M2PP-121-D-PLNM-0003

Site Specific Management Plan 003 - [sectors 360/370/380]  
MacKays to Peka Peka Expressway

01 SEPTEMBER 2014 - CERTIFIED ISSUE - REV C

## SITE SPECIFIC MANAGEMENT PLAN - WHAREMAUKU BASIN [SSMP 3 - SECTOR 360, 370, 380]

Title: SSMP 3[350/370/380] - SHEET 10  
KAPITI BRIDGE

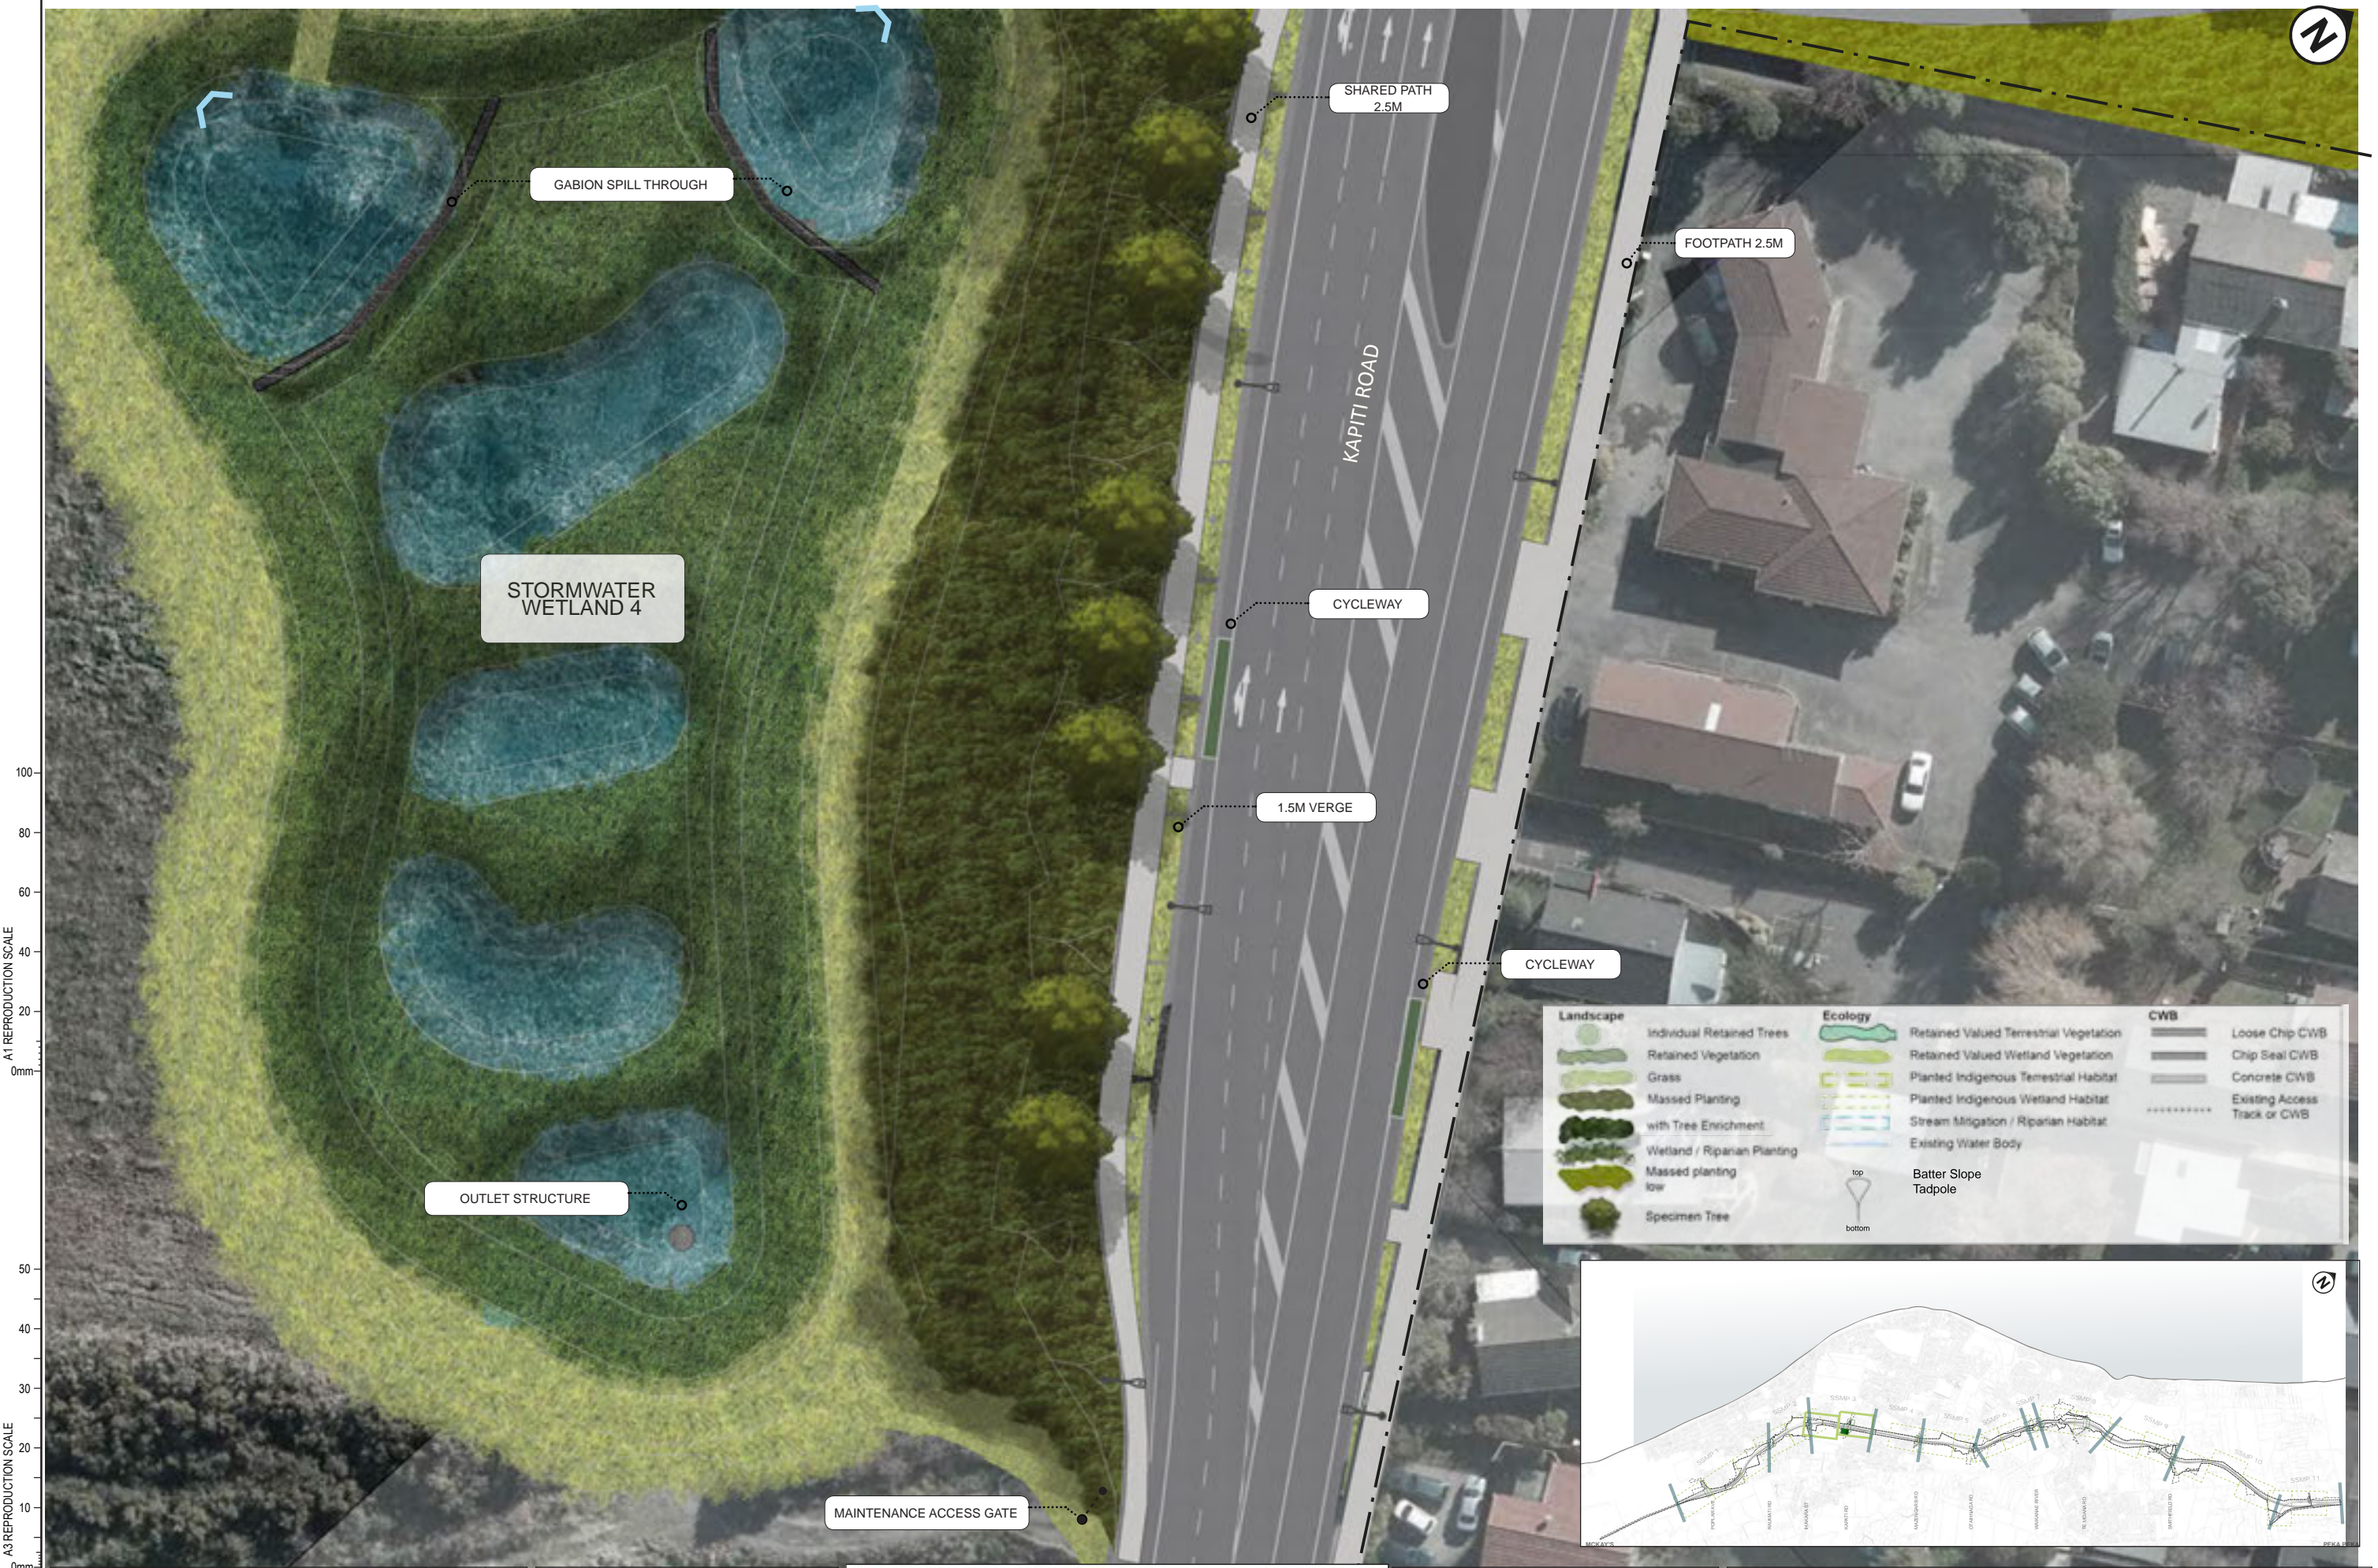
Condition Reference	Condition Detail	Reviewer/ commenter	KCDC Reviewer's comment	reference in SSMP	Management Plan Author's response
	CWB	SK	Indicate tactile pavers, painted cycle lanes and traffic island on plans.		Included on Sheet 10
	AEE Visual and Landscape plans	DP/JW	Changes to planting around Kapiti Road intersection including numbers and location of large grade trees and layout of Wetland 4.  Agree with proposed design changes and support the reasons/rationale. Planting covered in 'M2PP Planting Philosophy at Interchanges DRAFT 16 June 2014'.		No response required
	AEE Structural - Bridges	DP	Agree with proposed design changes and support the reasons/rationale stated in the SSMP document (with a special reference to Kapiti Road Crossing -Bridge Development Study M2PP-38R-D-REPG-010/Rev A and (Bridge Summary Wharemauku, M2PP-12-D-MPL).  The form of the Kapiti Road bridge and Wharemauku Stream bridge are different from the approved AEE scheme, in terms of column form and dimensions and also in terms of column number in the case of Wharemauku Stream Bridge. Further design detail provided for abutments' treatment. The new design is consistent with the revised approach to bridge design		No response required

Title: SHEET 20  
CWBI INTERSECTIONS

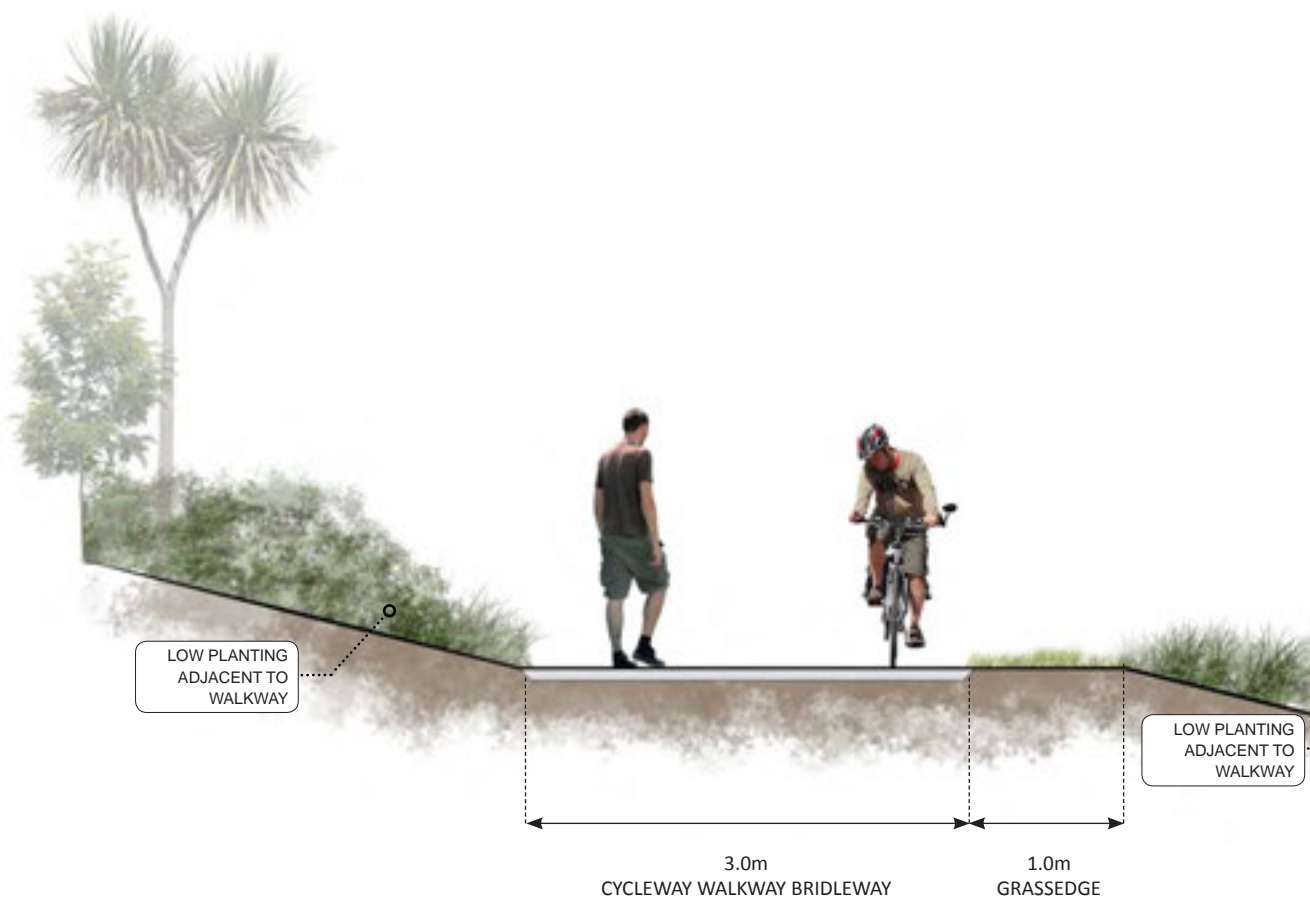
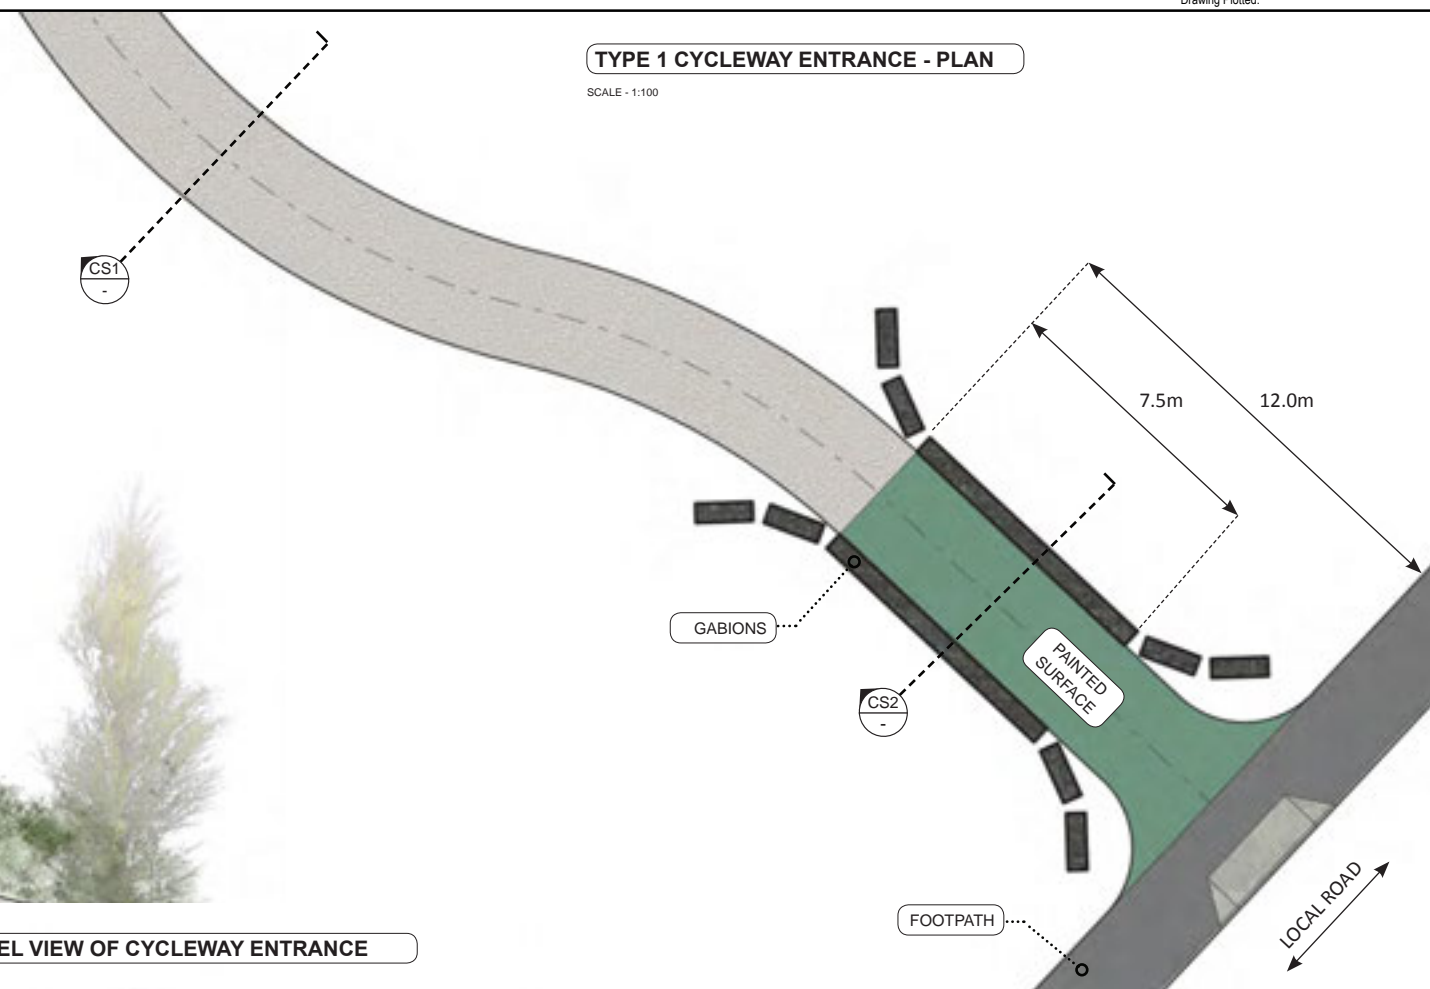
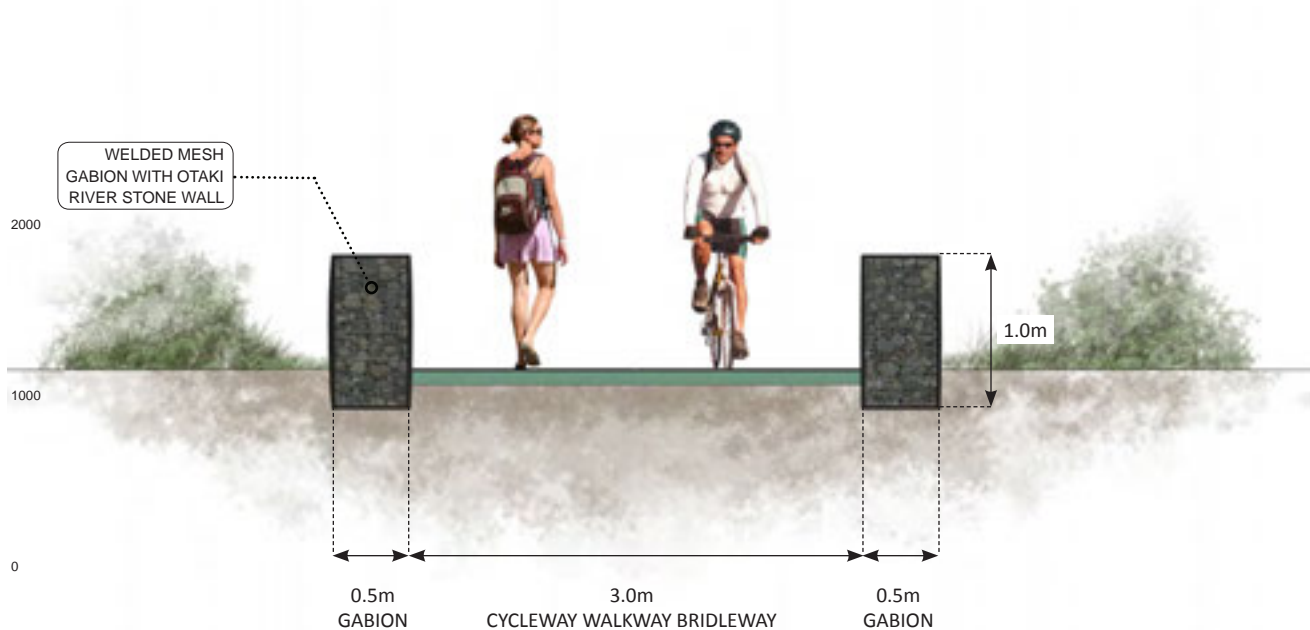
CWB entry details to be resolved and finalised.		The CWB entrances relevant to this SSMP will all be Type 1 entrance design, shown on Sheet 20
	LMP principles, methodologies and procedures (where appropriate)	DP/JW	These have been well thought through and established under previous SSMPs		No response required
	LMP Attachment 1 Landscape mitigation by character area	DP/JW	Appropriate		No response required
	Urban Design Conditions				
	Condition DC.59A e) requires SSUDPs to be prepared for locations where the Expressway interacts with local vehicular and non-vehicular pedestrian/cyclist movement. For SSMP4, the locations include: Ihakara extension /Wharemauku Stream	DP	Condition appropriately addressed (subject to clarifying the issues re: gateway significance)  Kapiti Gateway specifically noted on DC59A e): need to ensure that changes to large scale planting including using few large trees in the most prominent locations close to the bridge have not lessened the 'distinctive gateway' that was presented to		The Kapiti gateway includes all of the interchange, encompassing the Expressway and the local road locality, as this node will be experienced by users travelling and viewing it in all directions. The distinctiveness of the 'gateway' is provided through the planting design as well as the detailing of the underbridge space. Both the planting design and bridge abutment finishes are unique to the Kapiti interchange and provide a definite contrast to the rest of the Expressway.

Title	SHEET 26 CWB SIGN TYPE SUMMARY
-------	-----------------------------------

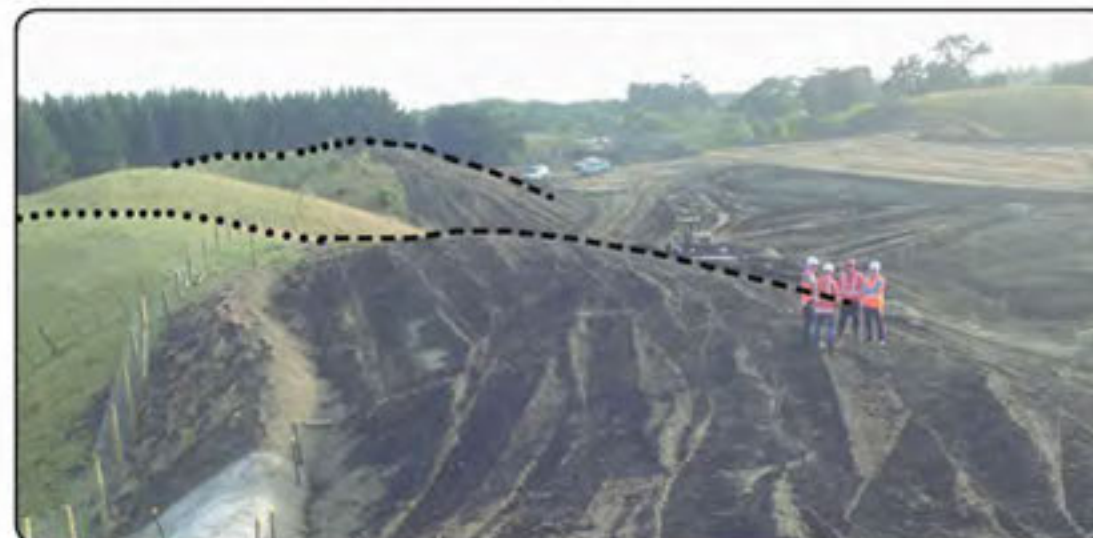
SHEET 26 - CWB sign type summary	M2PP-121-D-DWG-8901	Revision/Update	D	Signs updated to include horse symbol- All CWB signs to be updated as per this sheet	KCDC		3.5.16
Kapiti Road interchange planting plan SHEET 1	M2PP-38R-D-DWG-8201	Revision/Update	2	Removed planting in median strip (supersedes all other drawings that may show planting)	KCDC		3.5.16
Kapiti Road interchange planting plan SHEET 2	M2PP-38R-D-DWG-8202	Revision/Update	2	Removed planting in median strip (supersedes all other drawings that may show planting)	KCDC		3.5.16
Kapiti Road interchange planting plan SHEET 3	M2PP-38R-D-DWG-8203	Revision/Update	2	Removed planting in median strip (supersedes all other drawings that may show planting)	KCDC		3.5.16
Kapiti Road interchange planting plan SHEET 4	M2PP-38R-D-DWG-8204	Revision/Update	2	Removed planting in median strip (supersedes all other drawings that may show planting)	KCDC		3.5.16

Title: SSMP 3 [330-340-350]  
SHEET 28 - TYPE 1  
CWB ENTRANCE DETAIL

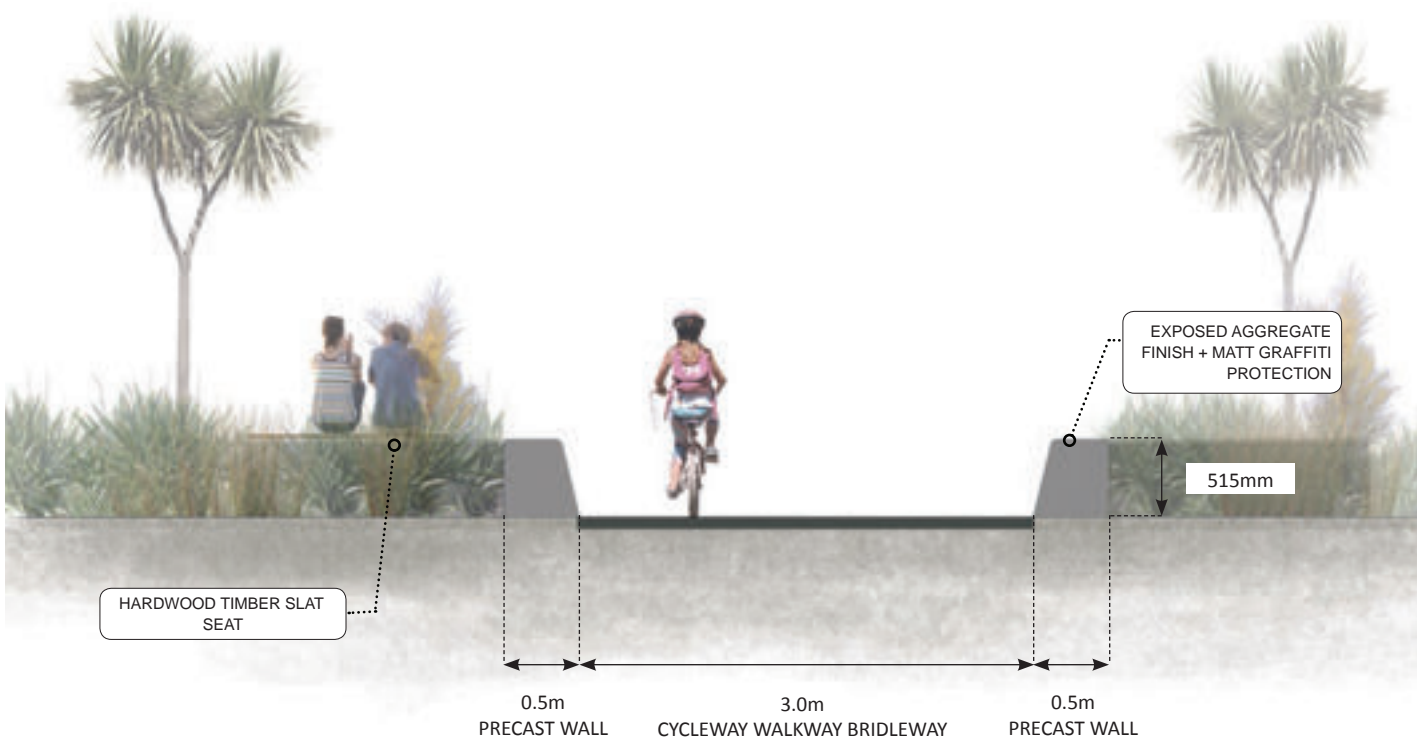
SSMP 3 SHEET 28 - Type 1 CWB entrance detail	M2PP-121-D-DWG-8802	New Sheet added	A	CWB entrance structures- design change to precast units. To replace Type 1 on sheet 18	KCDC		3.5.16
SSMP 3 SHEET 29 - Te Atiawa Column Design	M2PP-121-D-DWG-8803	New Sheet added	A	Page added to illustrate Te Atiawa design to be applied to Kapiti bridge columns (sand blasted etching)	KCDC		3.5.16
